UNITED STATES PATENT AND TRADEMARK OFFICE

APPLICATION NO.	FILING DATE	FIRST NAMED INVENTOR	ATTORNEY DOCKET NO.	CONFIRMATION NO.
10/049,834	02/19/2002	Wolfgang Scheibe	842FR/50684	2328

Office Action Summary

DETAILED ACTION

Examiner's Marked Up Figure #3

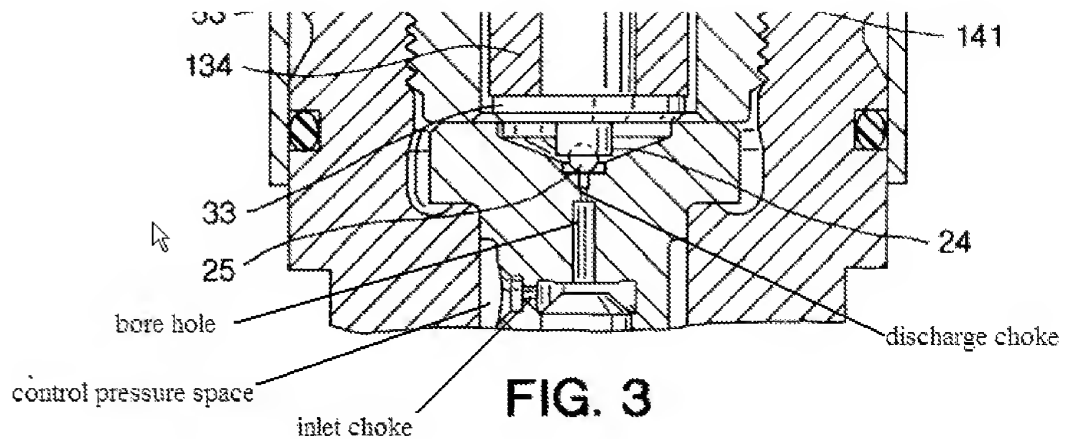
Regarding claims 14-19, and 31-37 the insert part (also forms a stop for the valve needle) is formed in two parts with a first part, which contains an opening for the passage fluid and a discharge or outlet choke (see examiners marked up figure 3) and a second part at the control pressure space side, with a bore hole (see examiners marked up figure 3) which connects the control pressure space (see examiners marked up figure 3) with an opening for the passage of fluid. The second part contains an inlet choke (see examiners marked up figure 3) near the bore hole (see examiners marked up figure 3). The pressure space is connected with an inlet choke and the rear end of the valve needle (see examiners marked up figure 3) averted from the nozzle needle seat surface lies in the control pressure space. The pressure insert part also including an inlet choke and an outlet or discharge choke (see figure below).
